World Forum for Harmonization of Vehicle Regulations

Progress on the development of new global technical regulations and of amendments to established global technical regulations – gtr No. 9 (Pedestrian safety)

Authorization for the development of amendments to gtr No. 9 (Pedestrian safety)

Submitted by the representative from the Netherlands *

"Figure 6A

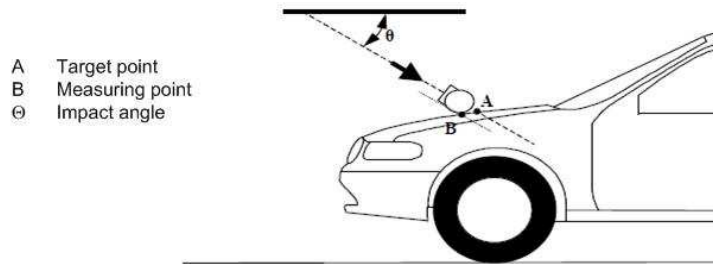
Figure 6, shall be deleted

Insert new Figures 6A to 6C, to read:

Measuring and target point in the vertical longitudinal plane through the center of the impactor (see paragraphs 3.30. and 3.25.)²

- "3.25. **Target point**" means the intersection of the projection of the headform longitudinal axis with the front surface of the vehicle (see point A in Figure 6A)."

- "3.30. **The measuring point for the headform test is a point in the vertical longitudinal plane of the vehicle, containing the centre of the impactor. In this plane, it is the point at which the impactor nominally first contacts the bonnet top (see point B in Figure 6A and Figure 6B). The first contact point may differ from the measuring point as a result of the geometry of the bonnet top.**"

Figure 6B

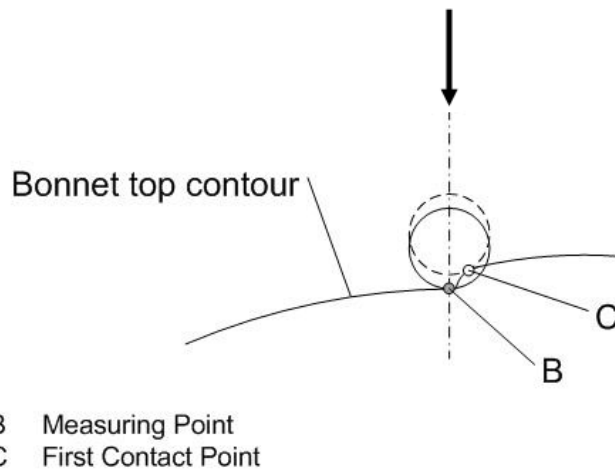
Measuring and first contact point (see paragraphs 3.30. and 3.19.)²
(schematic front view)

² Remark: due to the spatial geometry of the bonnet top, the first contact point C does, in most cases, not lie in the same vertical longitudinal or transverse plane which contains measuring point B.

- "3.19. **~~Impact~~ First contact point**" means the point on the vehicle where initial contact by the test impactor occurs. The proximity of this point to the target point is dependent upon both the angle of travel by the test impactor and the contour of the vehicle surface (see point C B in Figure 6B and Figure 6C)."

"Figure 11

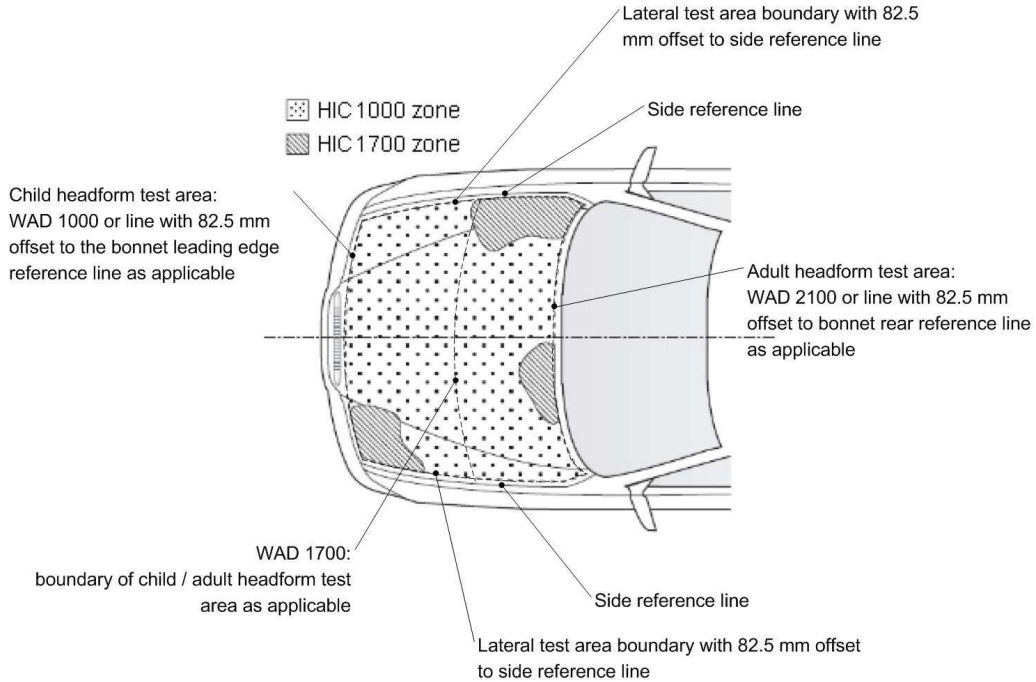
Figure 11(former), shall be deleted

Insert new Figure 11, to read:

Example of marking of HIC1000 zone and HIC1700 zone

"5.2.4.1. The manufacturer shall identify the zones of the bonnet top **test area** where the HIC must not exceed 1,000 (HIC1000 Zone) or 1,700 (HIC1700 Zone) (see Figure 11)"
